PLANNING COMMISSION AGENDA

REPORT TO CITY OF VISALIA PLANNING COMMISSION

SUBJECT: Finding of Consistency No. 2017-03: A request by Bob Rose, owner Black Bear Diner, to replace the traffic control spikes with a rolling gate to prevent access to Beverly Drive, in the Commercial Mixed Use zone (CMU). The subject site is located at 900 S. Mooney Boulevard (APN: 096-023-030).

ITEM NO: <u>g</u>	
SITE PLAN NO:	SPR17082
PROJECT TITLE:	BLACK BEAR DINER GATE
DESCRIPTION:	BEVERLY DR. INGRESS & EGRESS SPIKES BEING CHANGED TO A SENSORED GATE TO WITH HOLD CUSTOMERS FROM EXITING ON TO BEVERLY DR. (C-MU) (AE) (A)
APPLICANT:	ROSE BOB
PROP. OWNER:	900 SOUTH MOONEY BLVD LLC
APN:	096-023-030
LOCATION:	900 S MOONEY BLVD VISA

Exhibit "A"

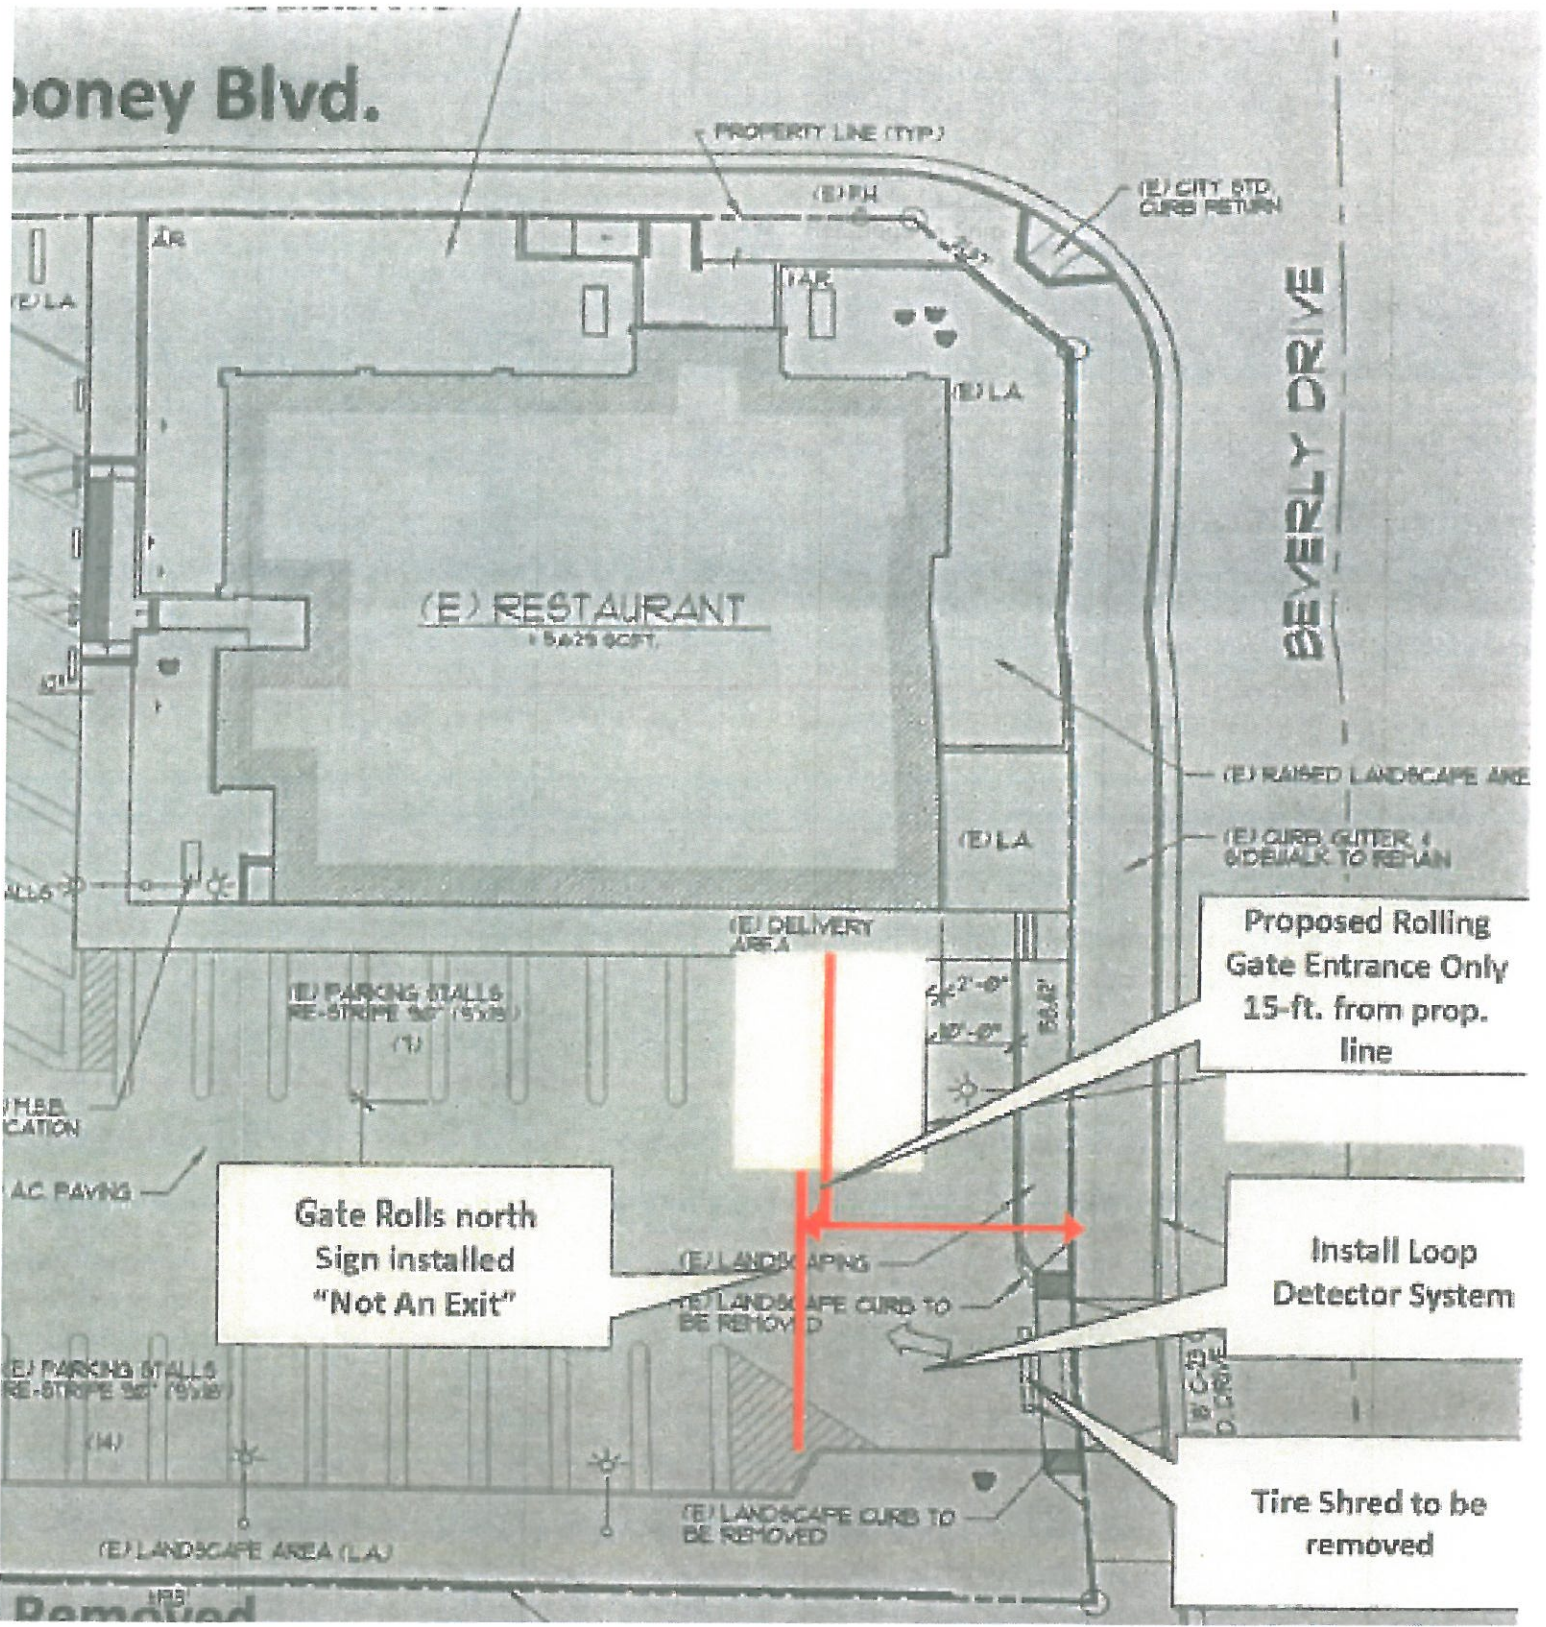
- Require 25-ft setback for gate from curb face for vehicle stacking.

- 1. Proposed new rolling gate shall be placed a minimum of 20' from face of curb - 25' is recommended.***
- 2. New loop system shall not encroach onto public sidewalk or obstruct pedestrian path of travel.***
- 3. Provide proper access restriction signage.***
- 4. A performance level rolling gate system shall be utilized to operate gate quickly - to not impede traffic on Beverly for entering vehicles/service trucks exceeding 20' in length.***
- 5. Gate width shall meet min. 20' standard per Fire Dept. Refer to further conditions.***
- 6. A building permit is required. Standard plan check and inspection fees apply.***
- 7. Refer to Planning Dept. for further entitlement conditions.***

1. A CUP Amendment is required for the removal of the spike-strip and installation of a motorized gate along the Beverly Ave. drive approach.
2. Provide a detailed site plan depicting the location of the fence and the setback distances from the property line.
3. Provide any additional information on the motorized gate including the length of time required for the gate to open.
4. All other conditions/requirements of the gate, including prohibiting existing/right-turns from the site onto Beverly Ave. will be incorporated as part of the Conditions of Project Approval for the amended CUP.
